**ADDENDUM NO. 1
TO
SPECIFICATIONS FOR
CARTAGO DRIVE LOW PRESSURE SEWER SERVICE
IMPROVEMENTS
DELHI CHARTER TOWNSHIP
INGHAM COUNTY, MICHIGAN**

ISSUED: May 10, 2016

HRC Job No. 20160059

APPENDUM NO.
FIG-1
ADD-1

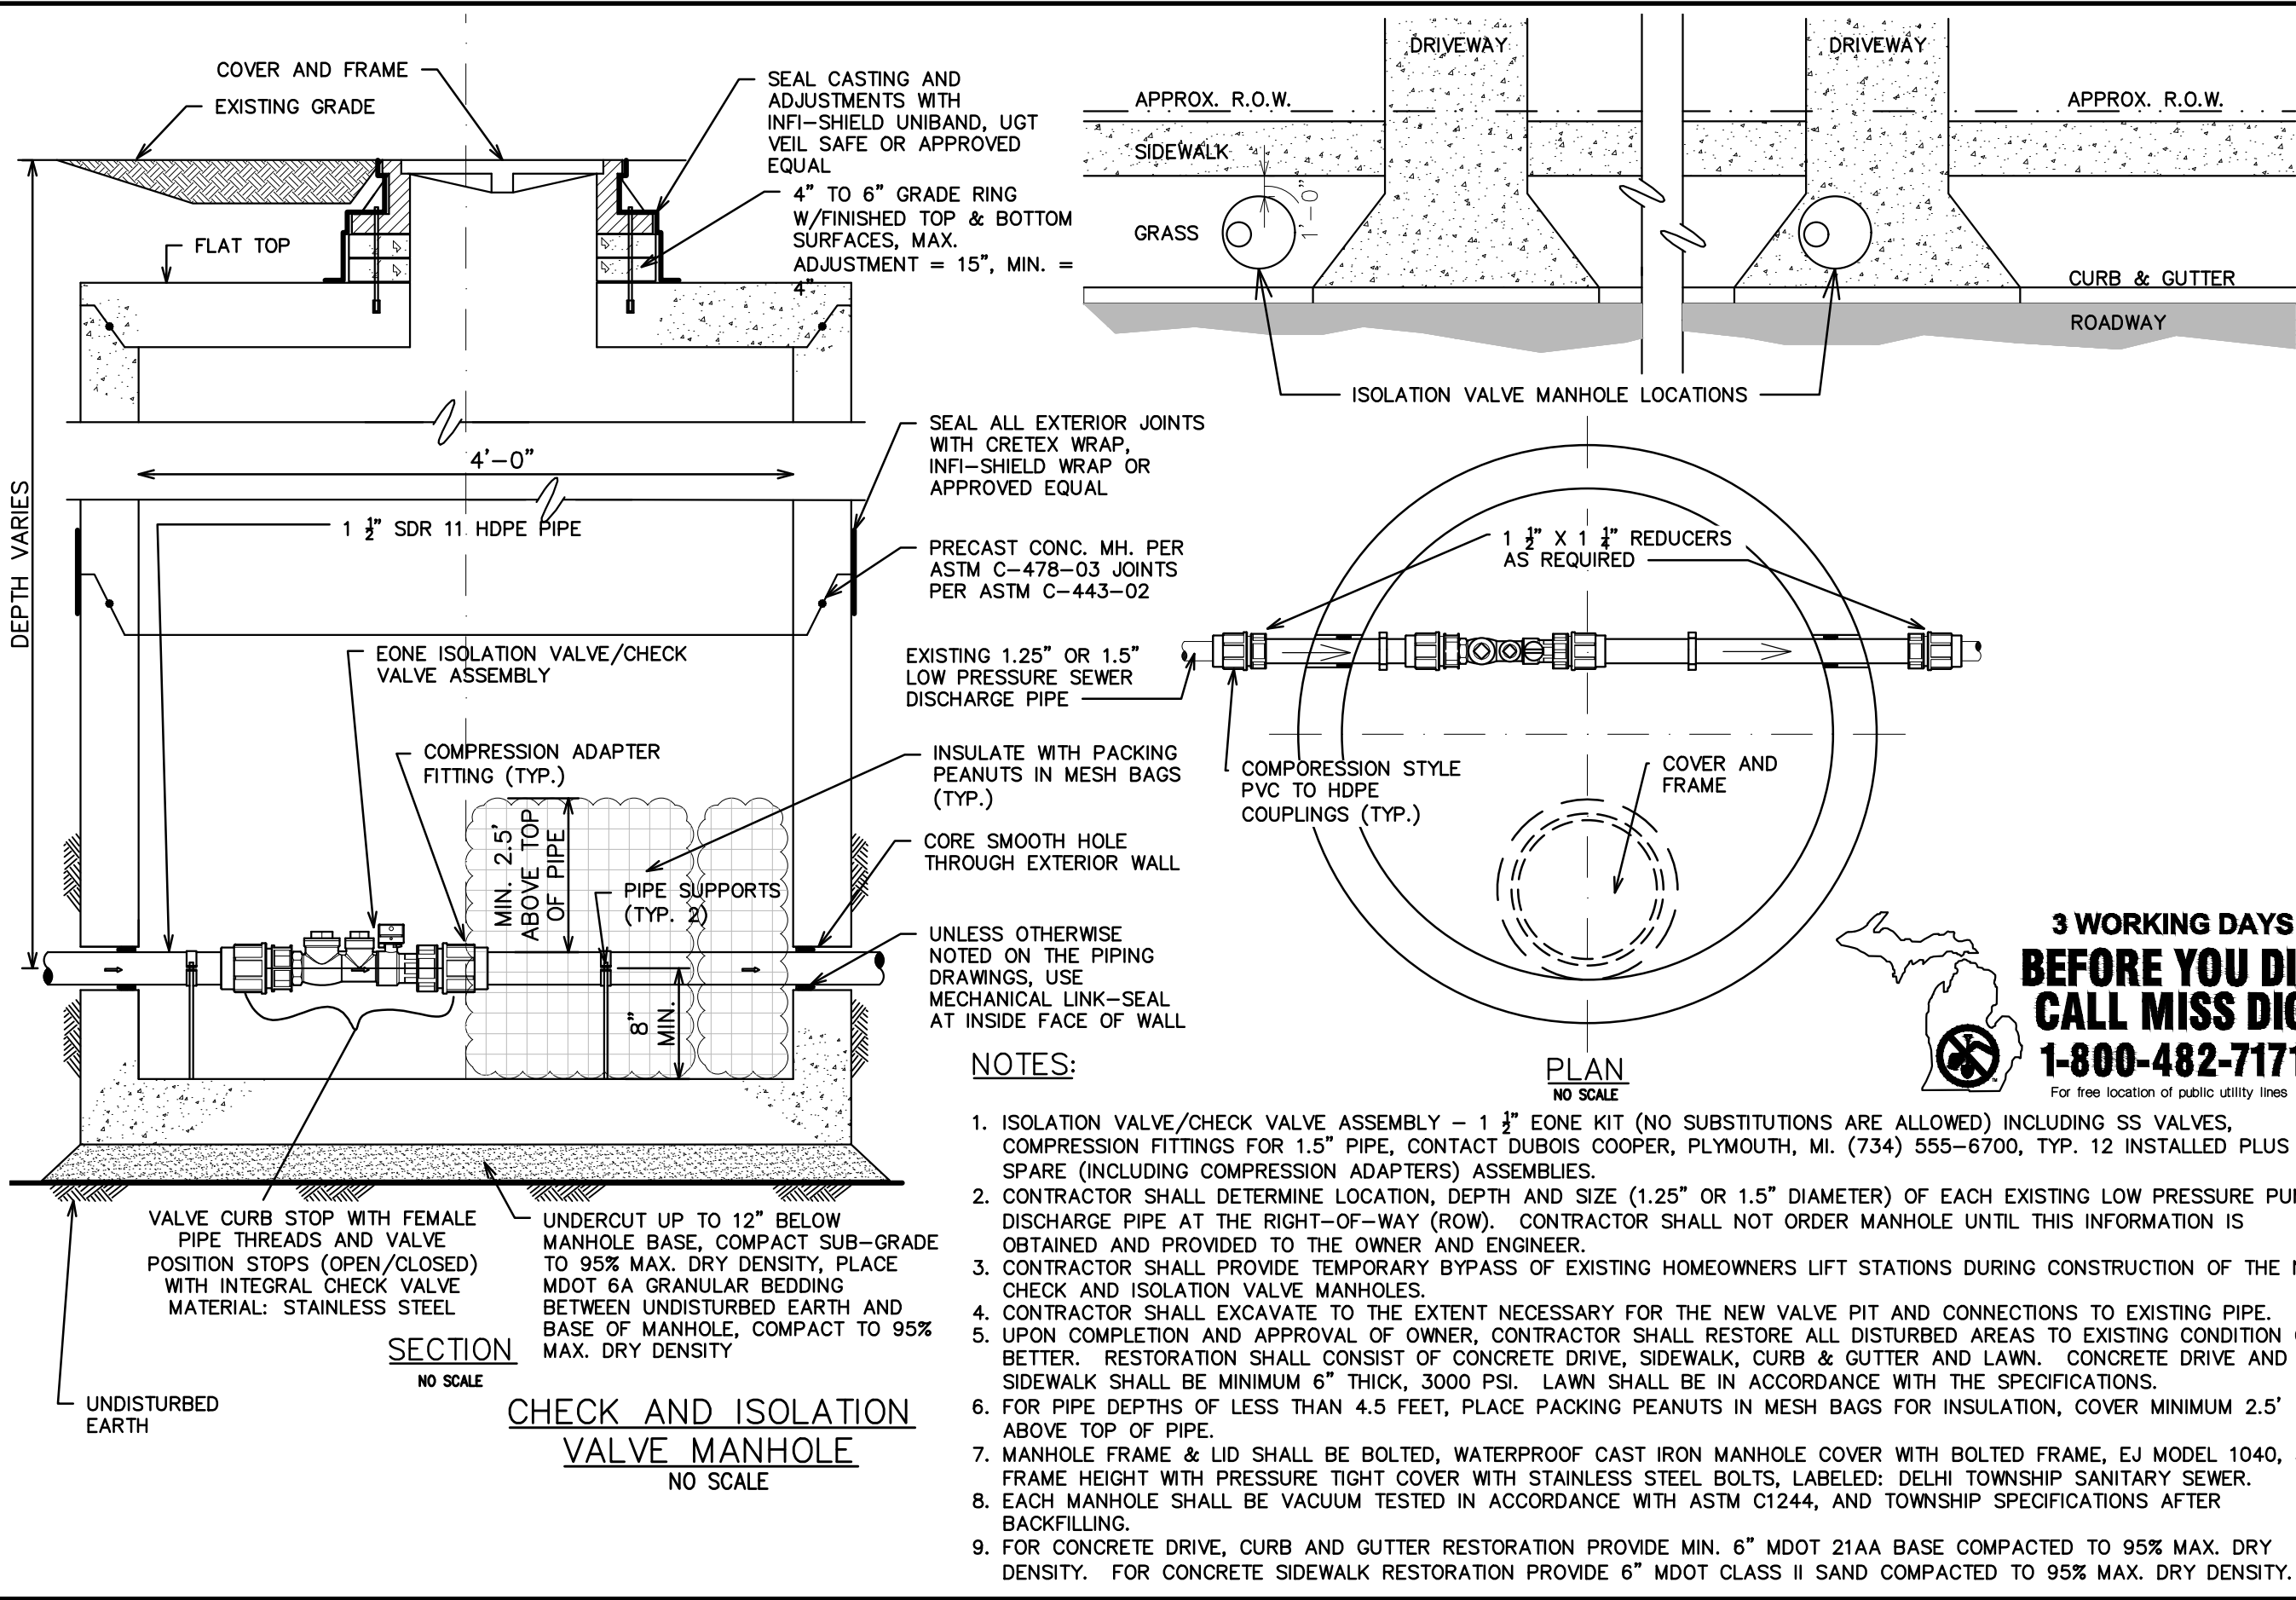
Modify the figure to revise position of check and isolation valves, add notes regarding construction.

1. ISOLATION VALVE/CHECK VALVE ASSEMBLY - 1 1/2" EONE KIT (NO SUBSTITUTIONS ARE ALLOWED) INCLUDING SS VALVES, COMPRESSION FITTINGS FOR 1.5" PIPE, CONTACT DUBOIS COOPER, PLYMOUTH, MI. (734) 555-6700, TYP. 12 INSTALLED PLUS 4 SPARE (INCLUDING COMPRESSION ADAPTERS) ASSEMBLIES.

2. CONTRACTOR SHALL DETERMINE LOCATION, DEPTH AND SIZE (1.25" OR 1.5" DIAMETER) OF EACH EXISTING LOW PRESSURE PUMP DISCHARGE PIPE AT THE RIGHT-OF-WAY (ROW). CONTRACTOR SHALL NOT ORDER MANHOLE UNTIL THIS INFORMATION IS OBTAINED AND PROVIDED TO THE OWNER AND ENGINEER.

3. CONTRACTOR SHALL PROVIDE TEMPORARY BYPASS OF EXISTING HOMEOWNERS LIFT STATIONS DURING CONSTRUCTION OF THE NEW CHECK AND ISOLATION VALVE MANHOLES.
4. CONTRACTOR SHALL EXCAVATE TO THE EXTENT NECESSARY FOR THE NEW VALVE PIT AND CONNECTIONS TO EXISTING PIPE.

6. FOR PIPE DEPTHS OF LESS THAN 4.5 FEET, PLACE PACKING PEANUTS IN MESH BAGS FOR INSULATION, COVER MINIMUM 2.5' ABOVE TOP OF PIPE.
7. MANHOLE FRAME & LID SHALL BE BOLTED, WATERPROOF CAST IRON MANHOLE COVER WITH BOLTED FRAME, EJ MODEL 1040, 5" FRAME HEIGHT WITH PRESSURE TIGHT COVER WITH STAINLESS STEEL BOLTS, LABELED: DELHI TOWNSHIP SANITARY SEWER.
